## **TEMPORARY DRAINAGE PROPOSAL**

APPLICATION SITE OF PROPOSED TEMPORARY PUBLIC VEHICLE PARK FOR MEDIUM GOODS VEHICLES FOR A PERIOD OF 3 YEARS AT LOTS 1621, 1623 (PART), 2700, 2703, 2704 (PART), 2705 (PART), 2706, 2707, 2708 (PART), 2709 (PART), 2710 (PART), 2711 (PART) AND 2713 (PART) IN D.D. 129, LAU FAU SHAN, YUEN LONG, NEW TERRITORIES.

**PROJECT NO. TDM/011\_TOP**

**Response to Comments on Temporary Drainage Proposal (Issue 1)**

Remarks 備註:  
**Appendix C - Proposed Drainage Plan**

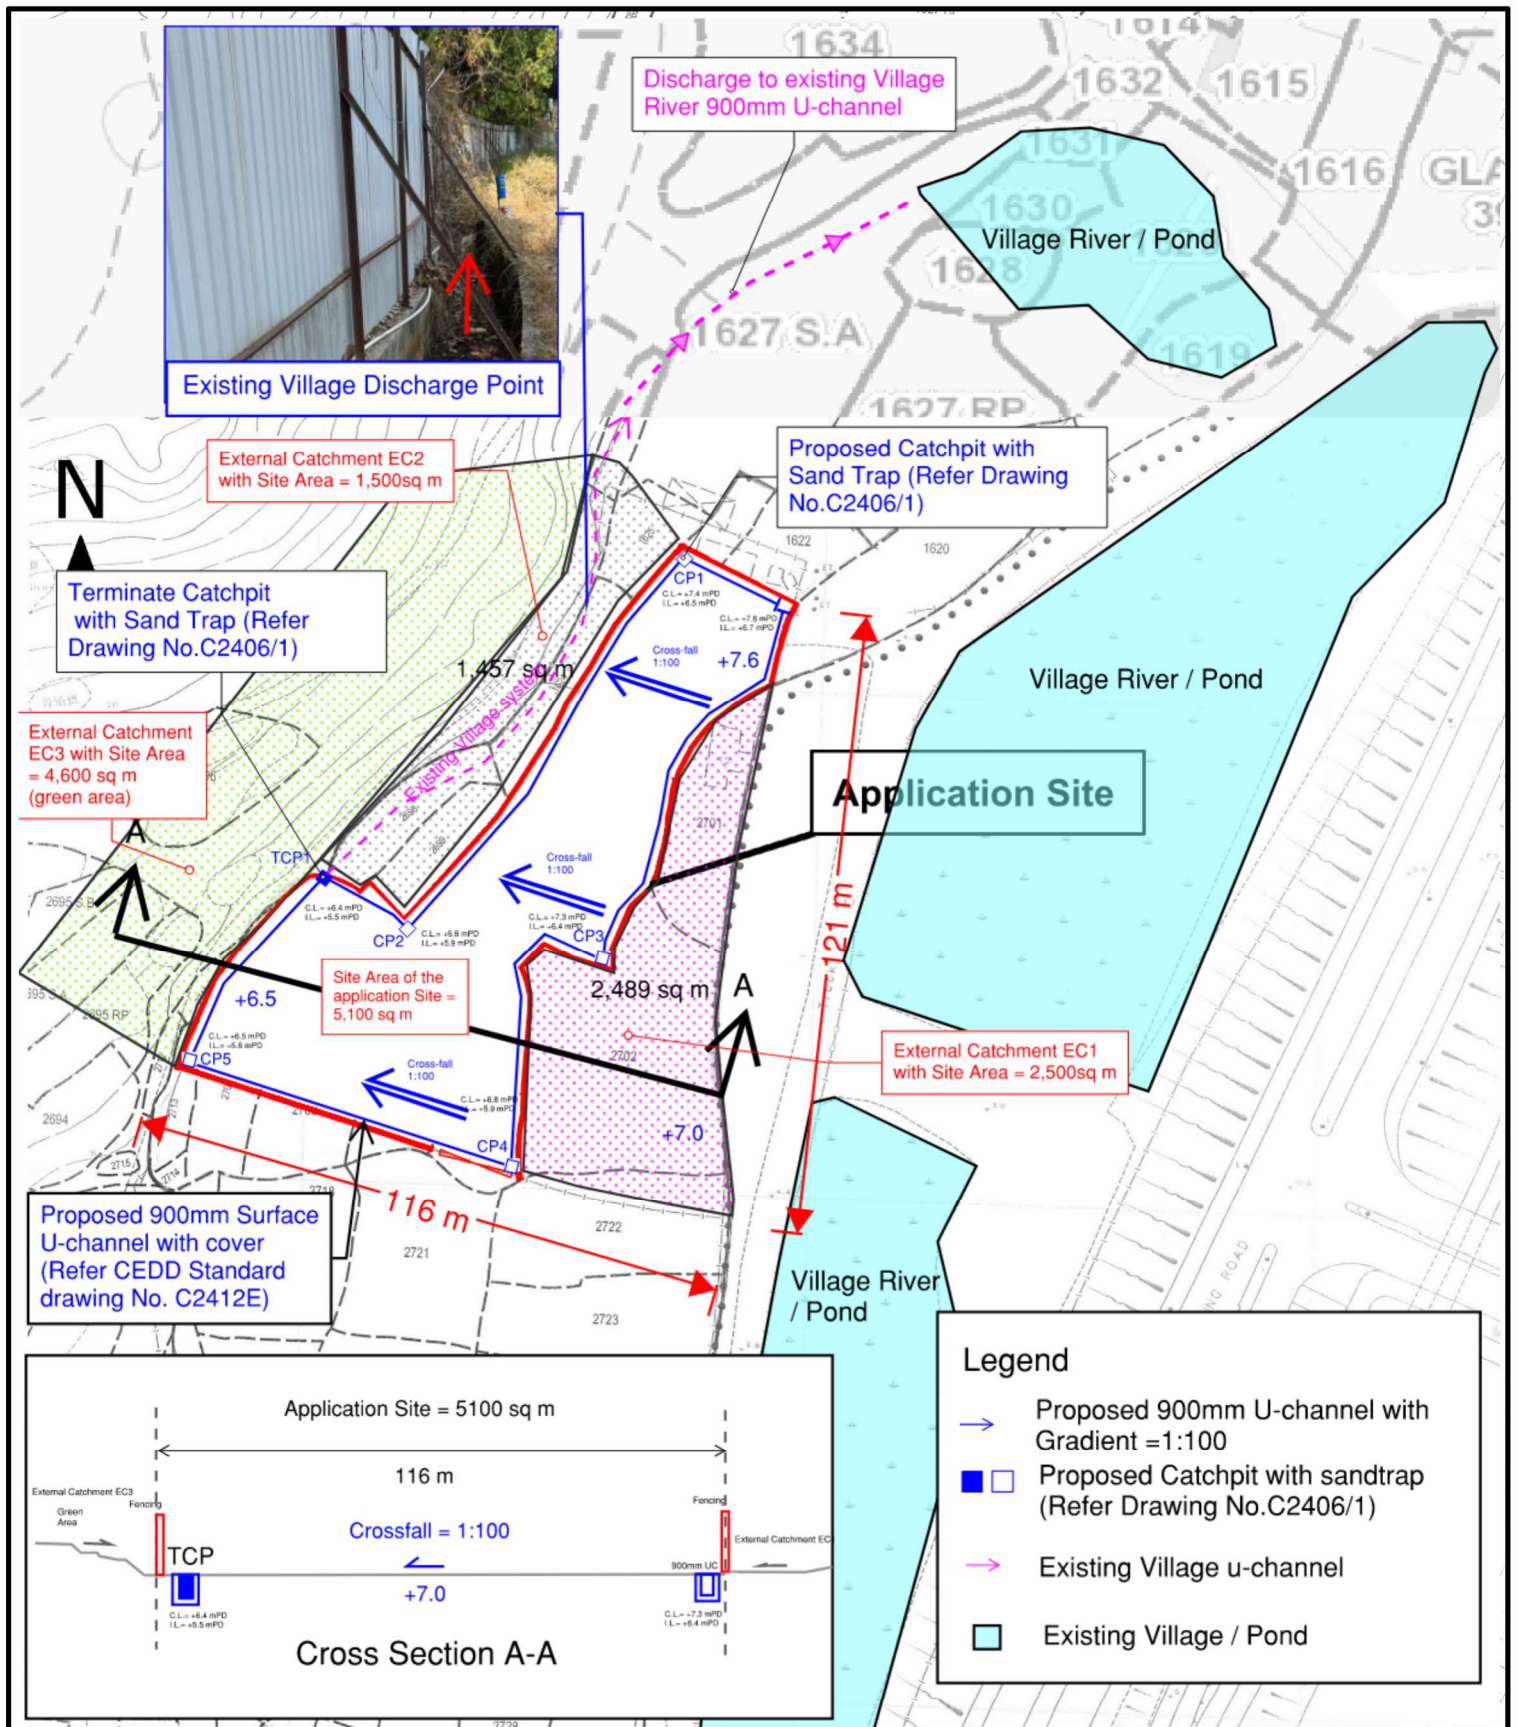
<b>No.</b>	<b>Comments</b>	<b>Response</b>
1.	Peripheral surface channels shall be provided along the site boundary to collect the surface runoff accrued on the application site and to intercept the overland flow from the adjacent land.	Noted. Please refer to the revised Appendix C – Drainage Plan.

3.	Further to item (ii) above, since there is no record of the said discharge path, please provide site photos to demonstrate its presence and existing condition.	Noted. Please refer to the Appendix C - Drainage Plan.

5.	Sand trap or provision alike should be provided at the immediate discharge point outside the application site boundary before the before conveying to any drainage system fall outside the application site.	Terminate Catchpit with Sand Trap is provided at the discharge point of the application site. Noted. Please refer to the revised Appendix C – Drainage Plan.

6.	Cross sections showing the existing and proposed ground levels of the captioned site with respect to the adjacent areas should be given.	Noted and provided. Please refer to the revised Appendix C – Drainage Plan.

Proposed FS Plan

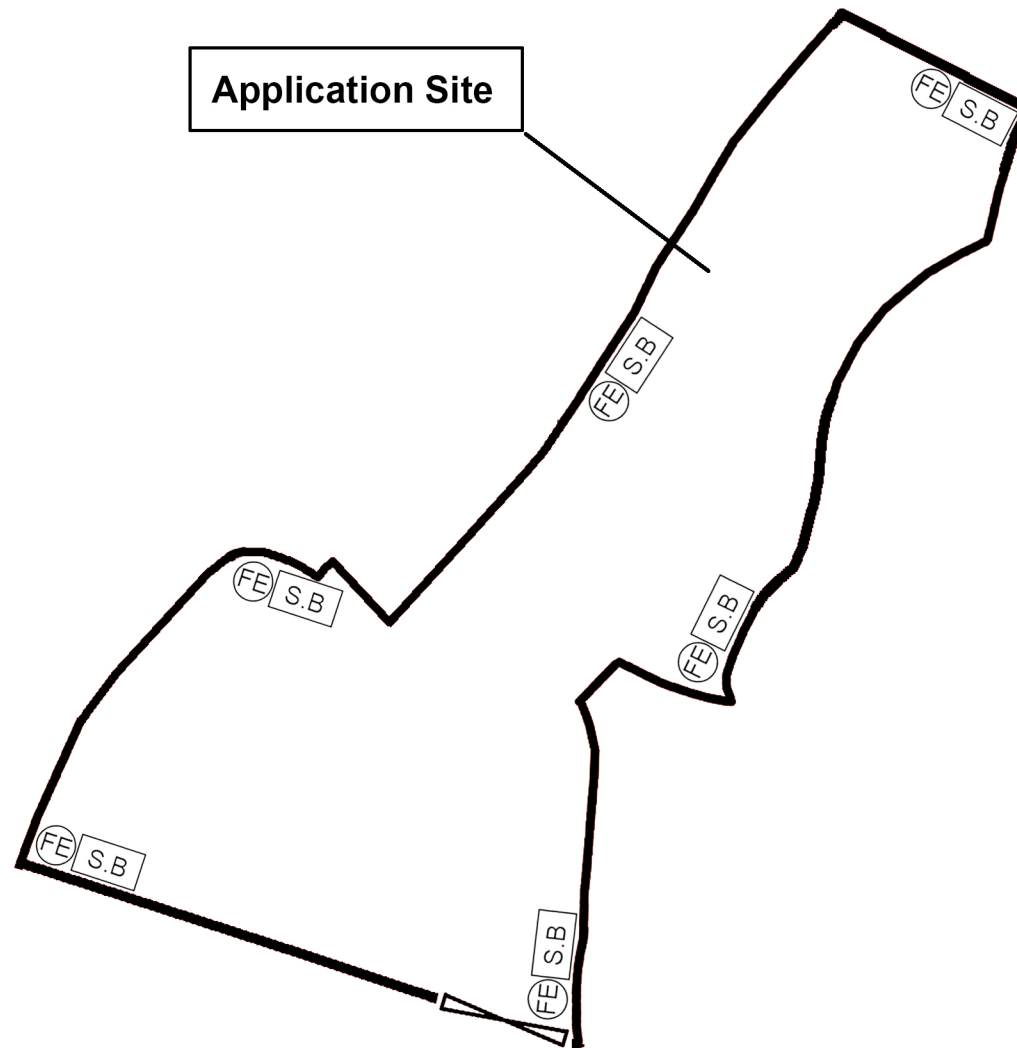
Departmental Comments	Responses
	Director of Fire Services	
(a)	Regarding the submitted fire service installations proposal, the proposed emergency lighting and directional and exit sign as mentioned in the FS Notes shall be clearly marked on plan.	申請用途是停車場，按照消防指引，申請地點不用擺放緊急照明燈及逃生指示牌，申請人之前遞交的消防圖則有誤，現已重新遞交更改過的消防圖則，請看附件 1。
